COUNCIL REPORT

Date:	January 7, 2021
From:	Erika Syvokas, Assistant Planner
Subject:	Proposed Heritage Alteration Permit for the Ferry Building
File:	1010-20-20-111

To consider proposed Heritage Alteration Permit No. 20-111 which would allow for alterations to the Ferry Building at 1414 Argyle Avenue, 101 14th Street, 1420 Argyle Avenue and 1430 Argyle Avenue (the Site).

Ferry Building plans prepared by DA Architects + Planners

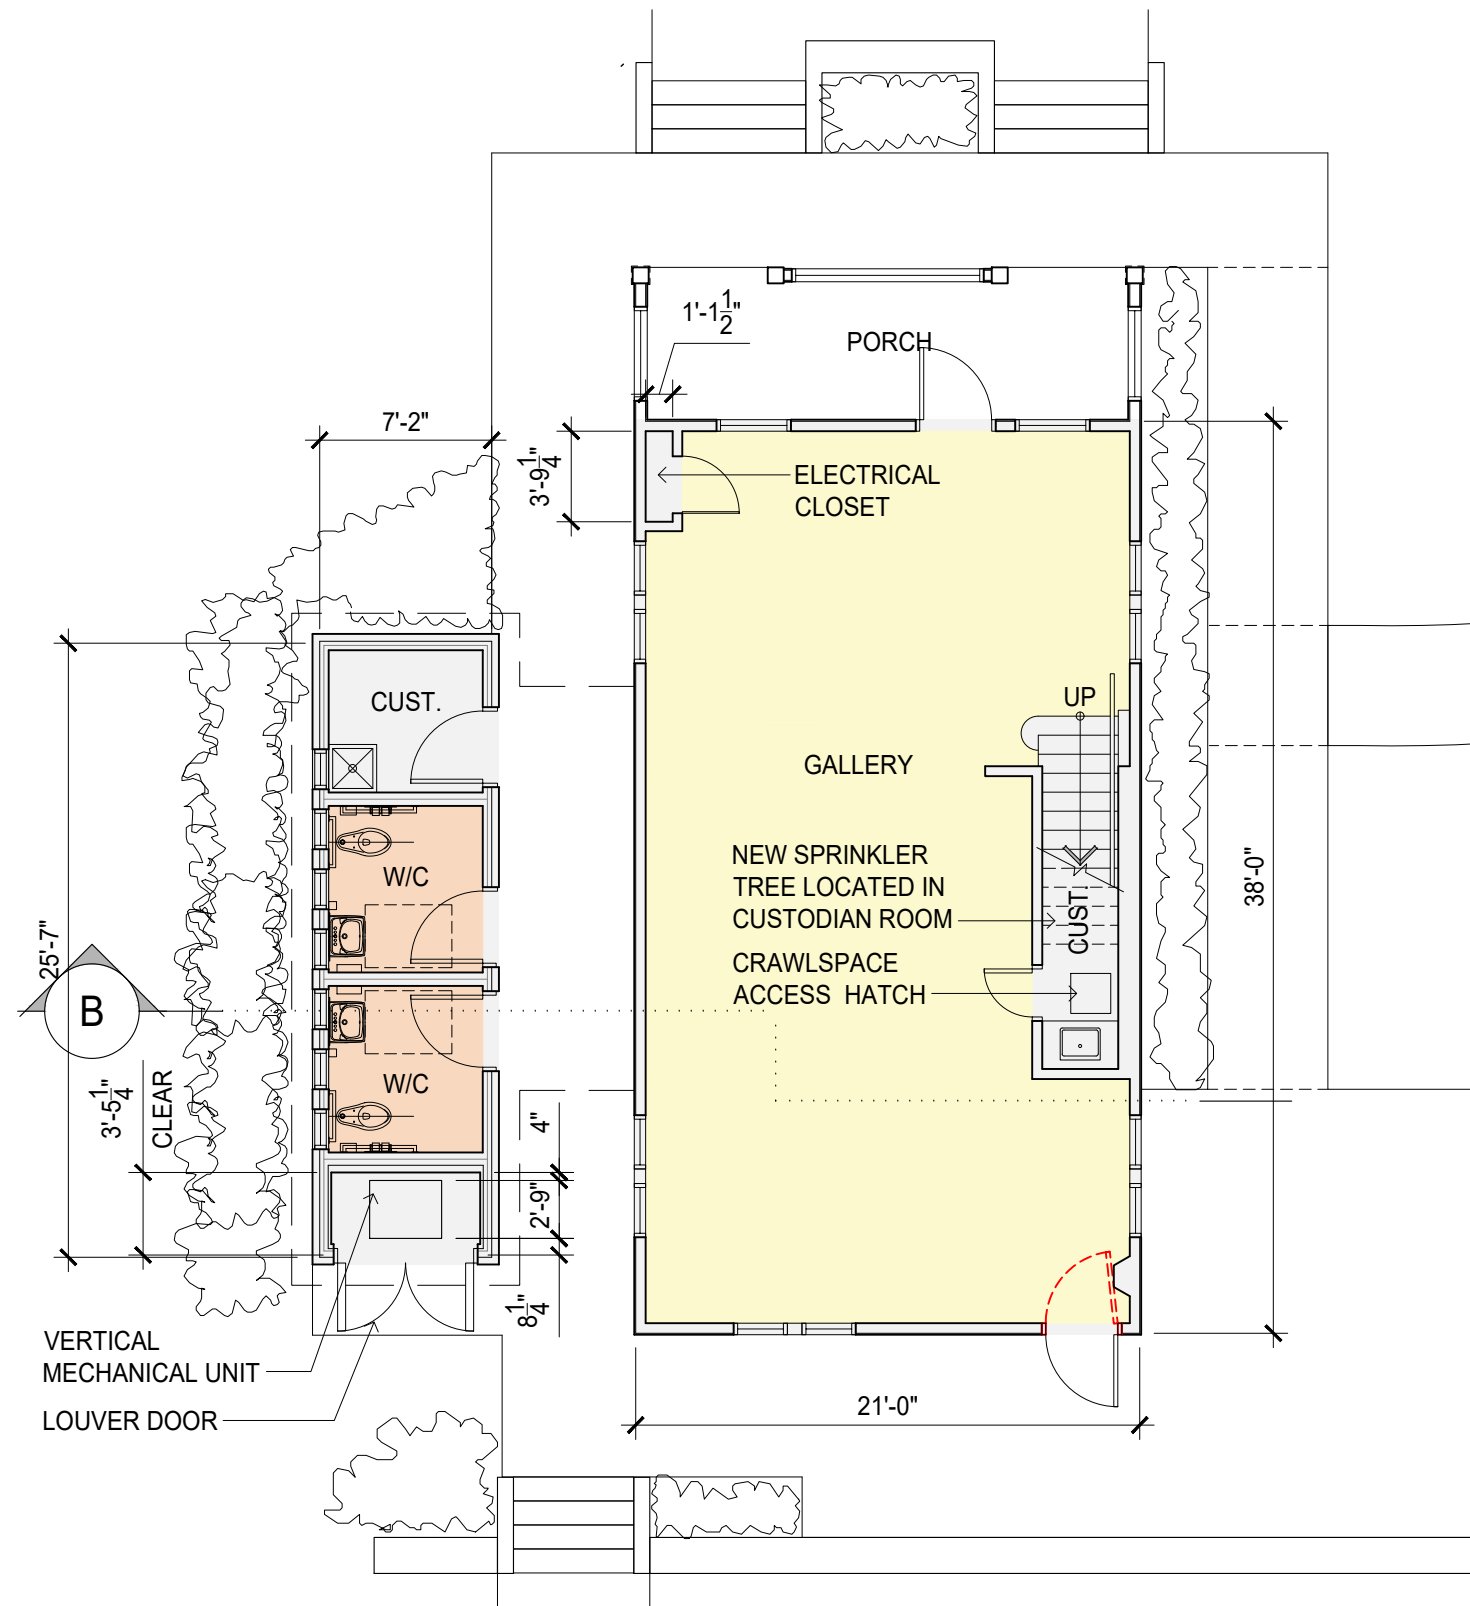
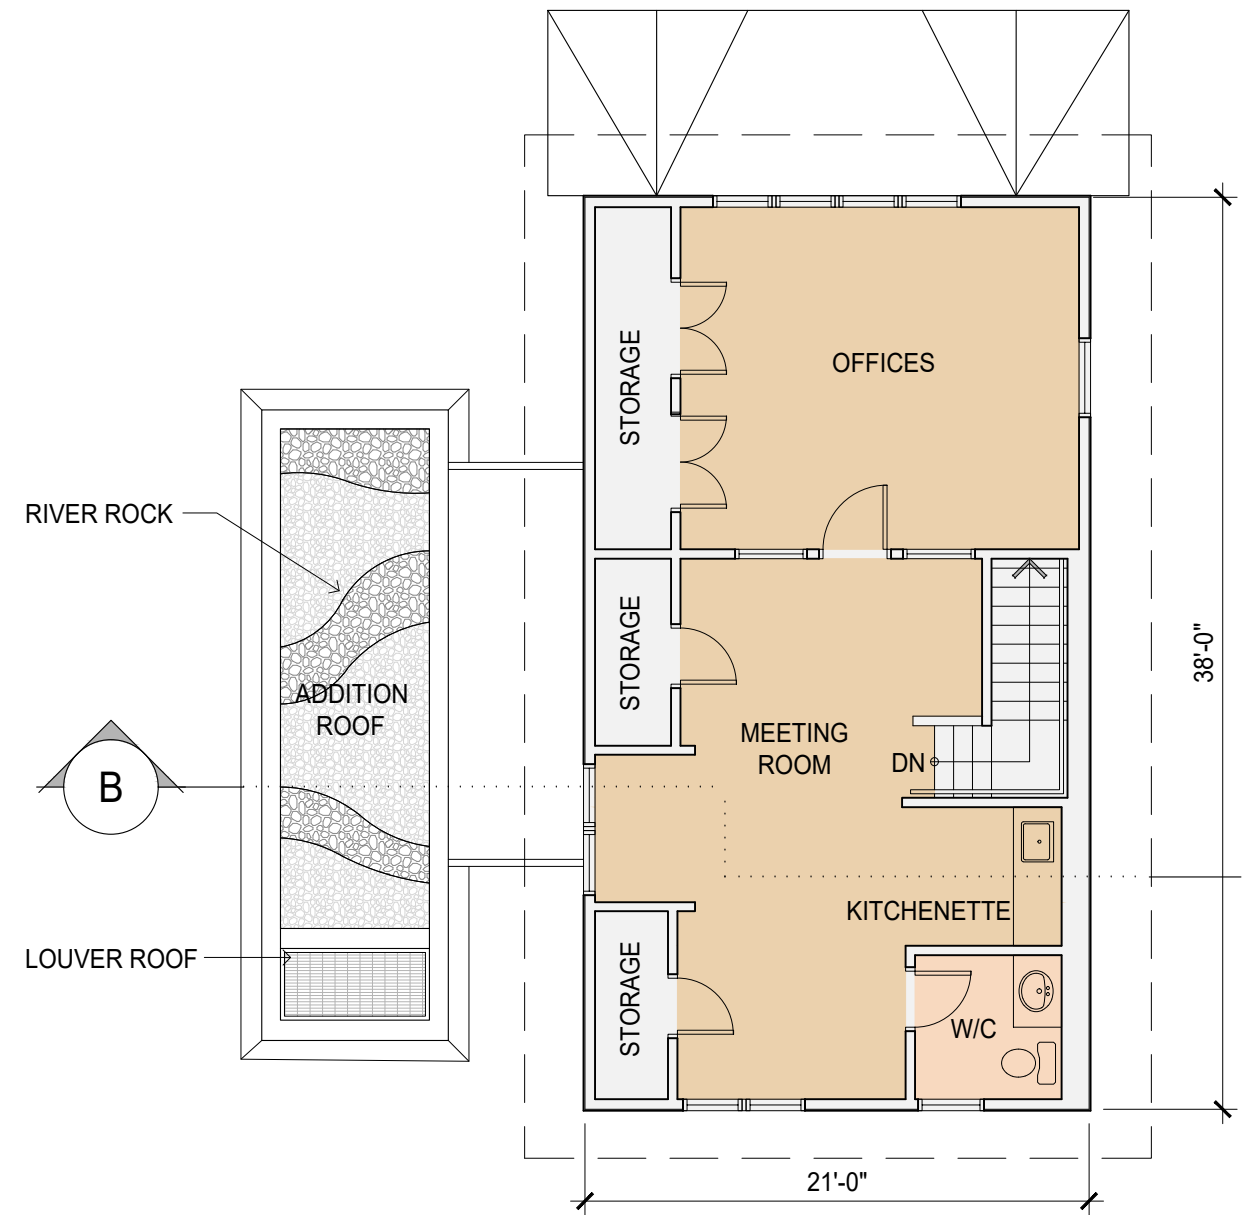
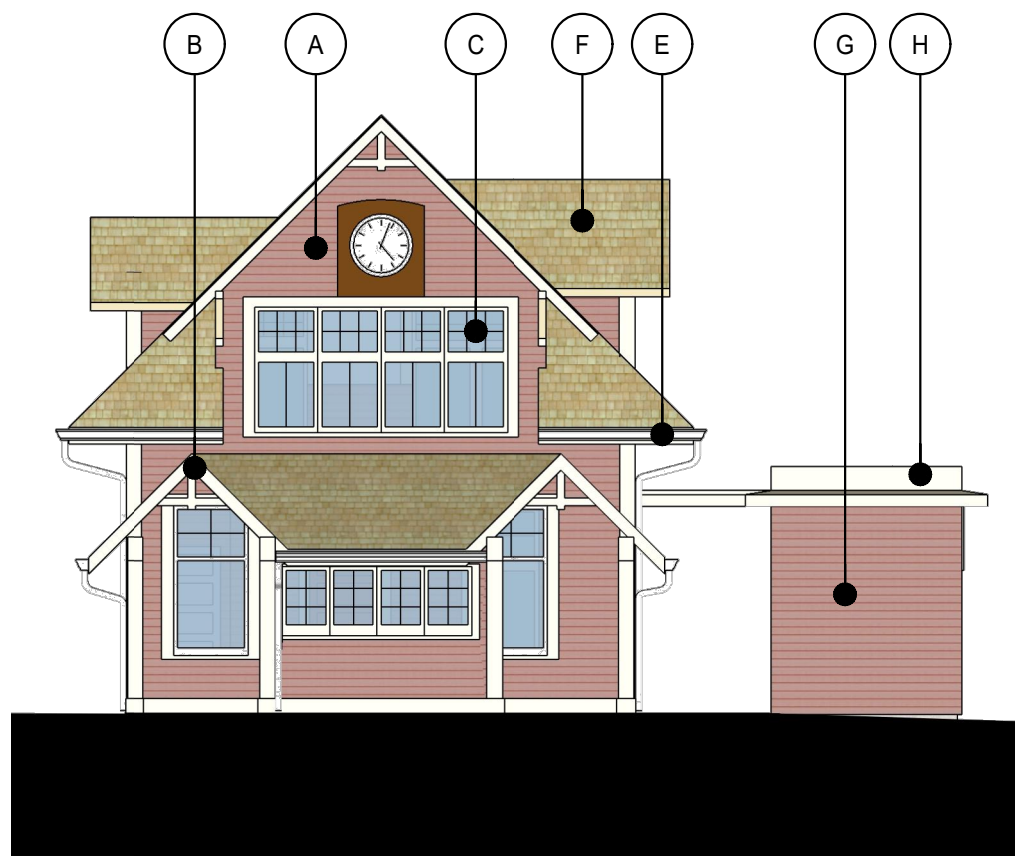
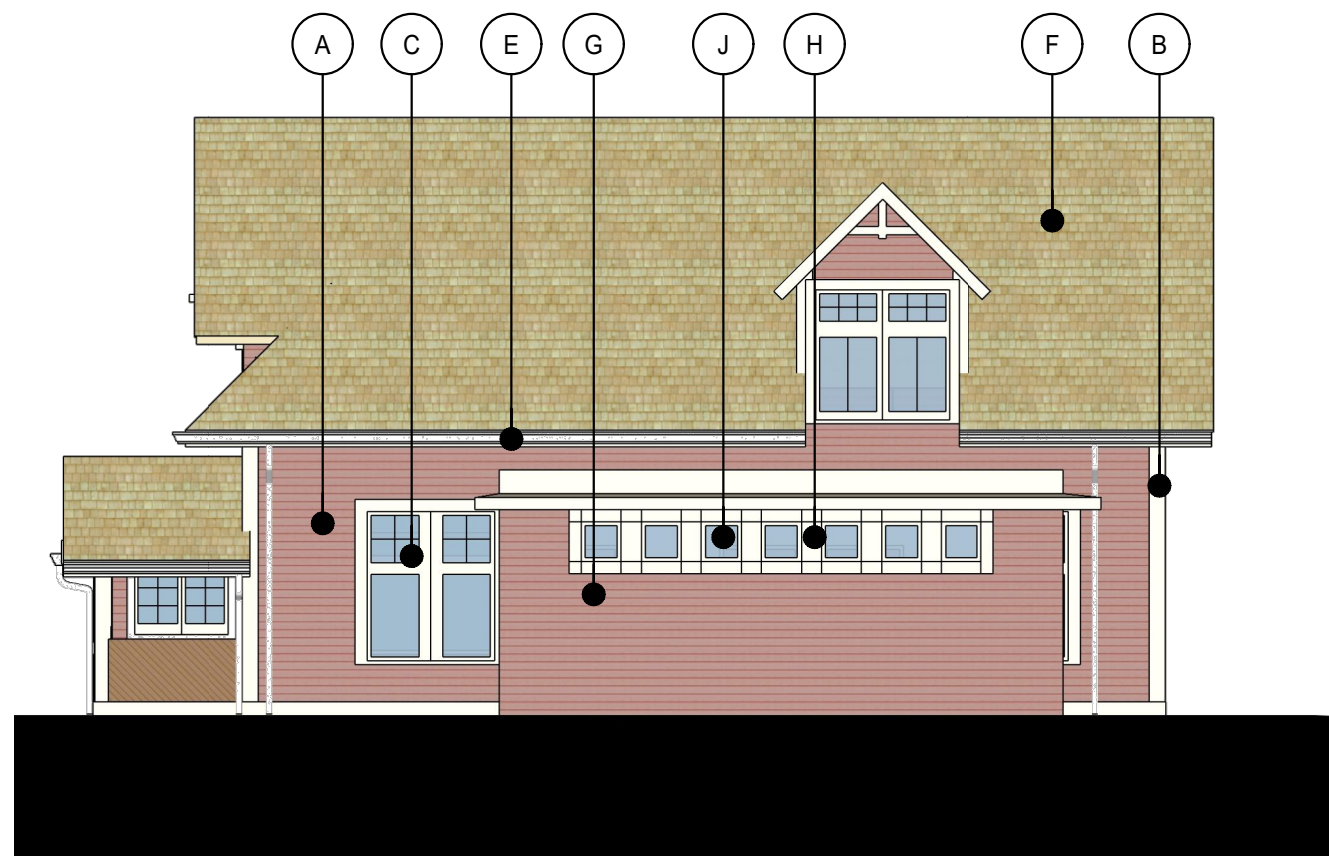
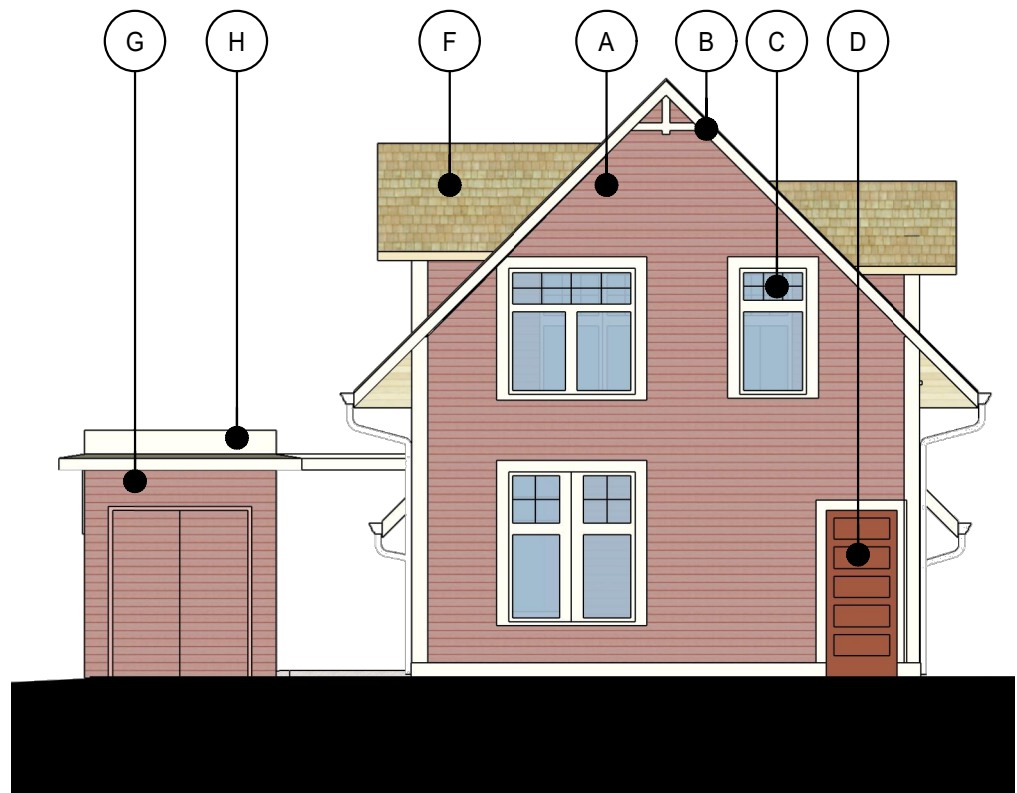
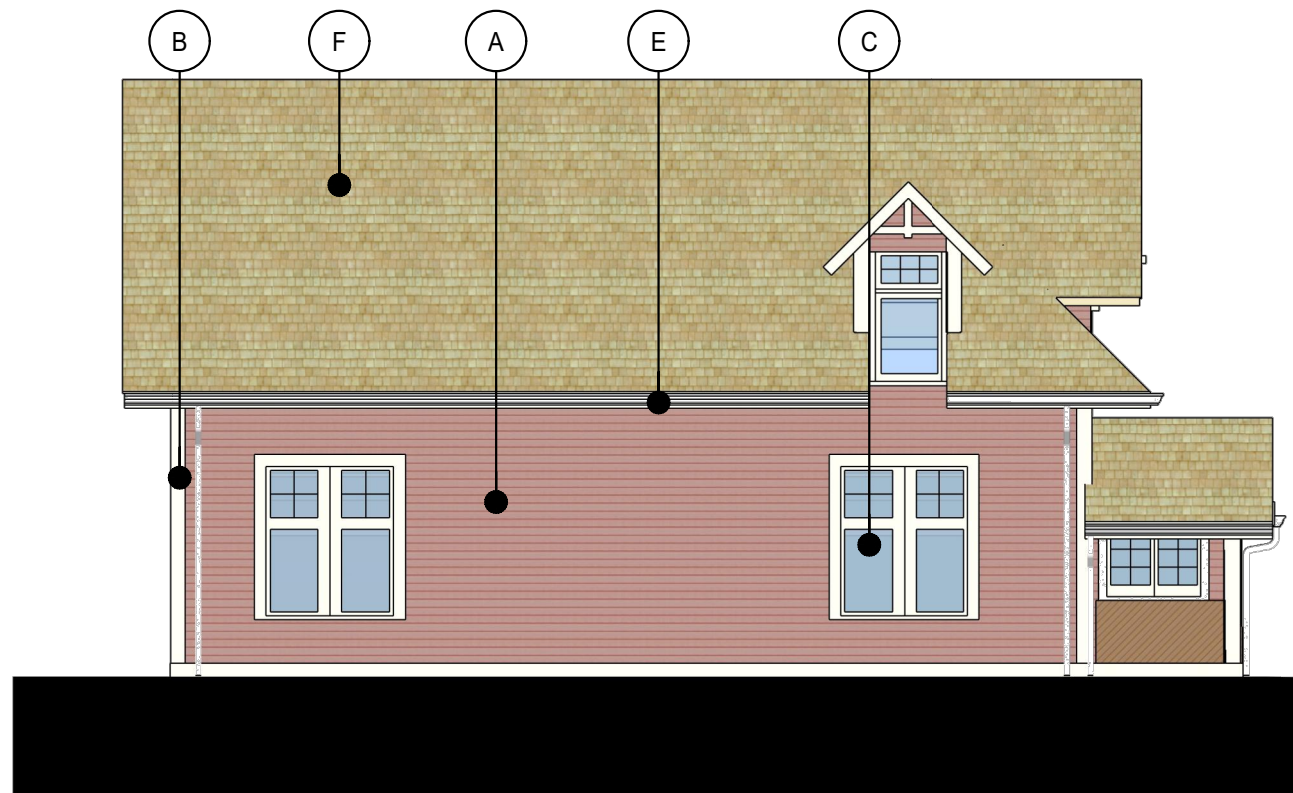
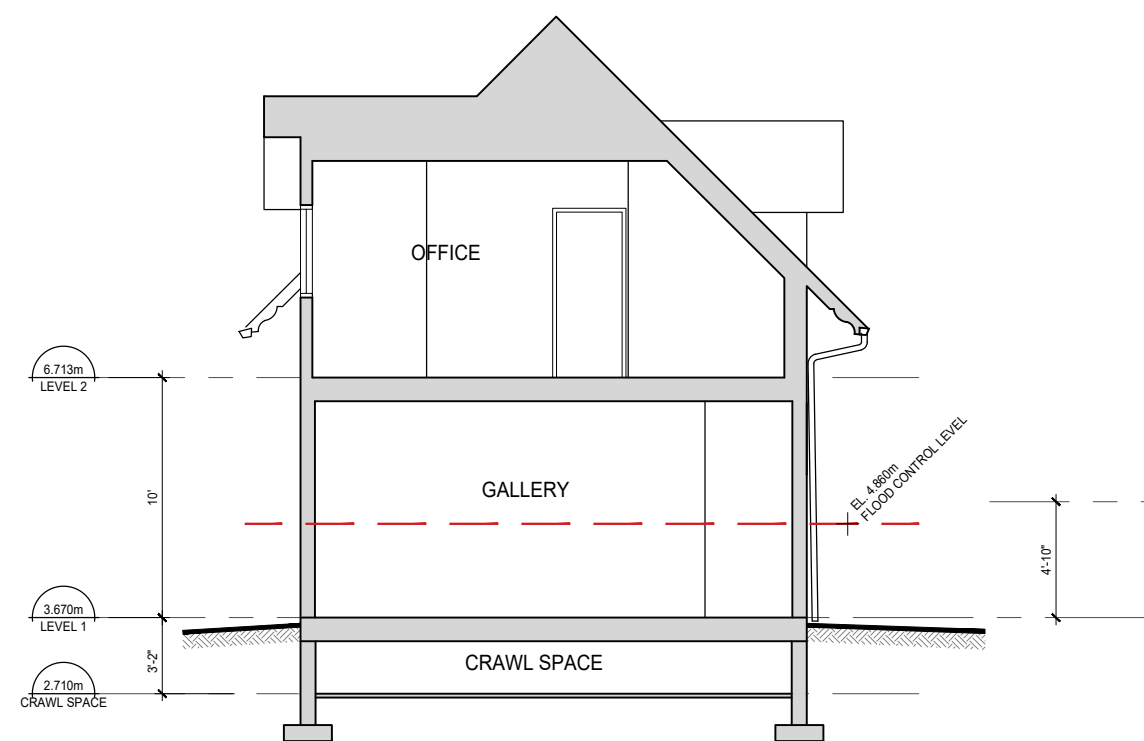
We refer to the email from Michael Sayachack of DA Architects + Planners dated 26th November 2020 and the Ferry Building plans attached to that email. For reference the drawings are appended to this letter as Attachment A. The drawings show modifications planned for the Ferry Building to accommodate the year 2100 Flood Construction Level (FCL) of +4.86 m CGVD2013.

The District has asked WSP to review the drawings and to provide advice on the flood control mitigation measures for the project.

The modifications proposed for the Ferry Building as detailed on the drawings in Attachment A involve siting the building on a mound with a floor level of +5.16 m. The datum used is not noted on the drawings and we assume the same datum (CGVD2013) applies, however this should be confirmed.

As the District is looking to address the general flood risk in the area as part of the Ambleside Park Plan, Item 3 above represents an acceptable approach.
